# Delegated Report

**Planning Application No:** 20240243

**Location:** 232 Singlewell Road Gravesend Kent DA11 7RE

**Description:** Demolition of existing bungalow and erection of two storey dwelling with rooms in the roofspace, erection of outbuilding in rear of garden, erection of bin store to front, alteration of existing frontage to create hard standing for parking, new boundary including existing access.

**Existing and Proposed Streetscene Views:**

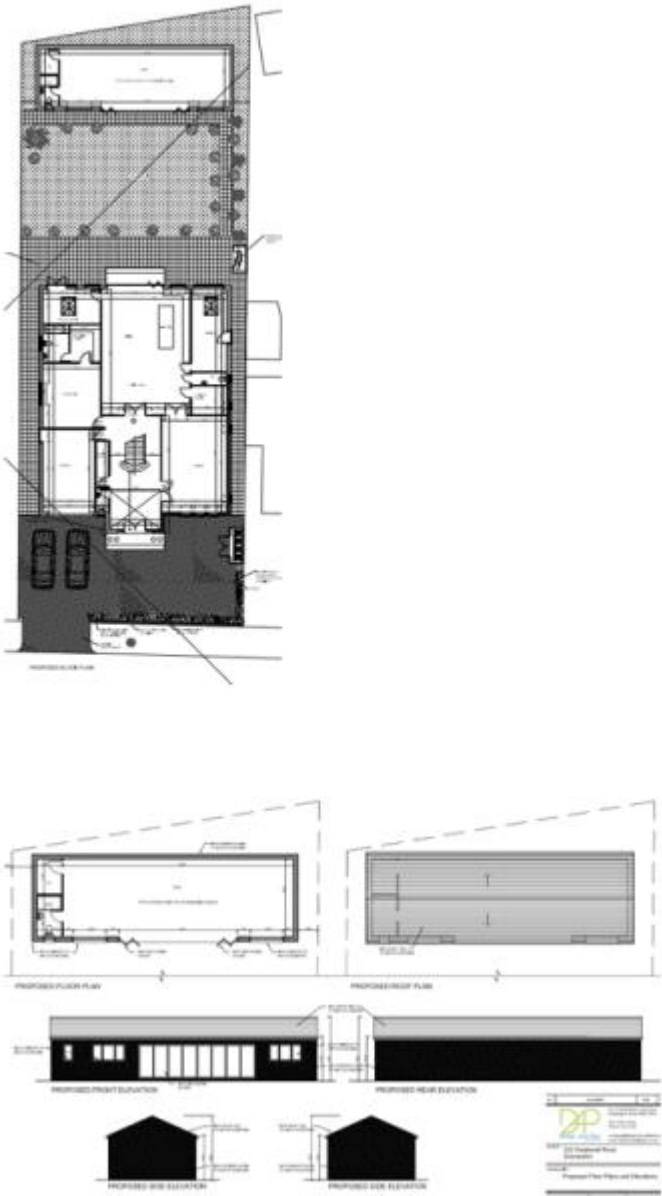
The proposed dwelling is still considered overly large in its immediate context. It is noted that it has been reduced in height (from 8.4m to 8m), set further back and the depth has been reduced (from 20.3m to 17.8m) however, as evident from the proposed streetscene view the proposed dwelling would still be much taller than the bungalow at no. 230 to the north. It is noted that the dwelling would now be the same height as the two storey chalet bungalow at no. 234 to the south. No. 230 is 6.7m in height, the proposed dwelling has been reduced to 8m in height. The full two storey design of the dwelling with an eaves height much higher than either no. 230 or 234 means it still appears overly large in its context between the bungalow at no. 230 to the north and the chalet bungalow design to the south at no. 234. Whilst it is appreciated that the site is located in Singlewell Road where there are a number of large two storey dwellings including such as at. no. 256 which is similar to the dwelling proposed here, it is the immediate context that the application site sits within that needs to be considered.

the two storey dwellings start. Whilst it is appreciated that any replacement two storey dwelling would be greater in height than the bungalows to the north, it is considered that care still needs to be taken to ensure the dwelling is not overly large in comparison to them so as not to be such a drastic change between the lower single storey dwellings in this part of Singlewell Road and the taller two storey dwellings. No. 234 which is the first two storey dwelling next to the existing run of bungalows which includes the application site is mostly a fairly modest two storey property with a part chalet style bungalow/part two storey element which represents a gradual increase in size between the bungalows and where the two storey dwellings start in this part of Singlewell Road.

In summary, although there are large dwellings in Singlewell Road, the immediate context has to be considered. No. 232 is located in between bungalows to the north and two storey dwellings to the south. The amendments to the current scheme of a slight decrease in height of 400mm, the dwelling being further set back and a decrease in depth of 2.5m are noted. However, the proposed dwelling would still be larger and more dominant than the surrounding dwellings. It would be much greater in height than the bungalow to the north and much greater in depth and footprint than the surrounding dwellings and also of greater bulk and massing.

The proposed replacement dwelling by virtue of its size, bulk, massing and design would be an overly dominant and incongruous form of development which would not be in keeping with the immediate streetscene it is situated in. The positive contribution that the existing dwelling makes to the streetscene would be replaced with a development that would cause harm to the character and appearance of the streetscene. In this respect the proposal is contrary to Policy CS19 (LPCS) and section 12 of the NPPF (2023). As such ground of refusal no. 1 of application ref. 20231268 has not been resolved.

45 degree test on plan from nearest rear window:

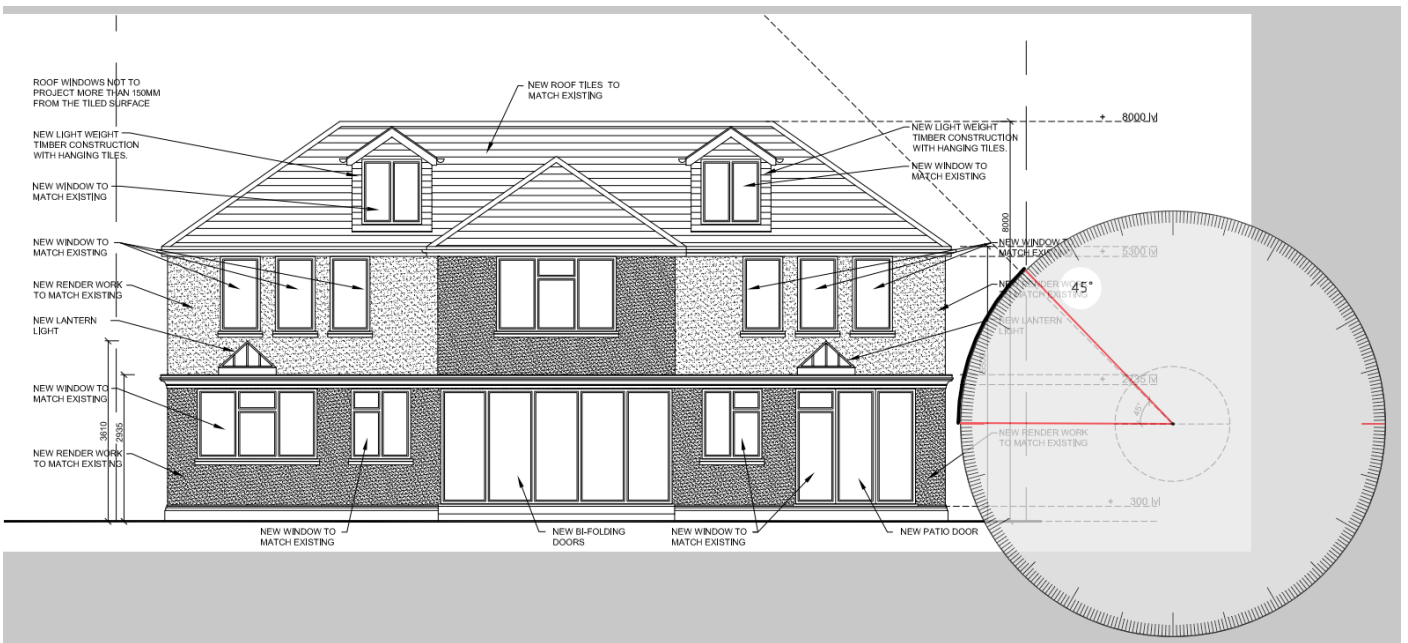
As can be seen the proposed dwelling would not project beyond the 45 degree line from the nearest rear and front windows on both plan and elevation thereby denoting that the proposed dwelling would not cause actual overshadowing or loss of light to the nearest front and rear windows of no. 230.

However and notwithstanding that the proposed dwelling has been slightly reduced in height (from 8.4m to 8m) and depth (from 20.3m to 17.8m), due to its sheer size with the dwelling still being 17.8m in depth and its height at 8m together with its proximity to no. 230, it is considered that the dwelling would still have a very overbearing impact on no. 230 and would generally be an unneighbourly form of development.

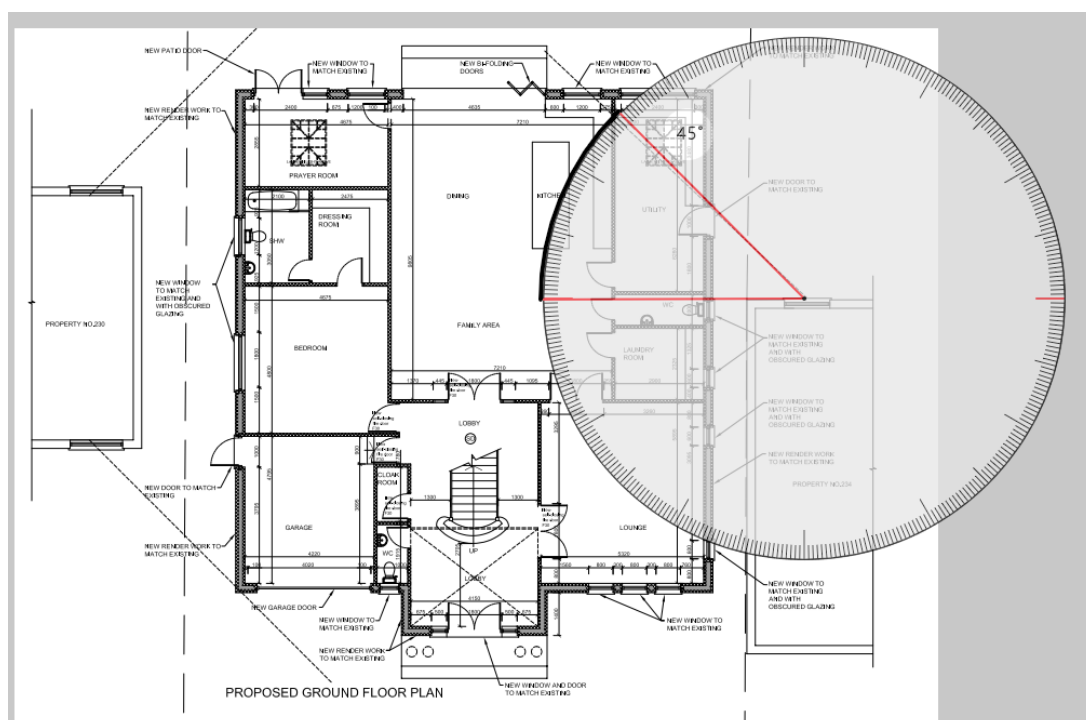
This is the two storey property to the south of the application site. This property has a standard rectangular footprint and so does not have staggered front or rear building elevations. The 45 degree and 25 degree tests have been carried out as follows:

As can be seen the proposed dwelling would project beyond the 45 degree line on plan but not elevation, as it does not fail both this denotes there would be no undue overshadowing to the nearest ground and first floor level windows on the rear of no. 234. There are no perpendicular windows so the 25 degree test is not relevant.

The proposed balcony at first floor level has been removed so the issues regarding overlooking from that balcony have also been removed. Due to the depth and height of the large expanse of brick boundary wall on the north flank of no. 234 there would not be overlooking or perception of overlooking from the nearest habitable room windows in the rear elevation at first and second floors to no. 234 as would be the case with no. 230. In terms of windows in the flank elevation facing no. 234 there would be a utility room (door), wc, laundry room and lounge at ground floor level and a shower room and bathroom at first floor level. The lounge is a habitable room but in any case all windows at ground floor could be screened by a boundary treatment to a height of 1.8m (by condition if permission were forthcoming). The windows are first floor level are non-habitable and would be obscured glazed and could be conditioned to be non-opening unless 1.7 above finished floor level in those rooms. The rooflights in the flank roofslope would by their outlook not afford any overlooking to no. 234.
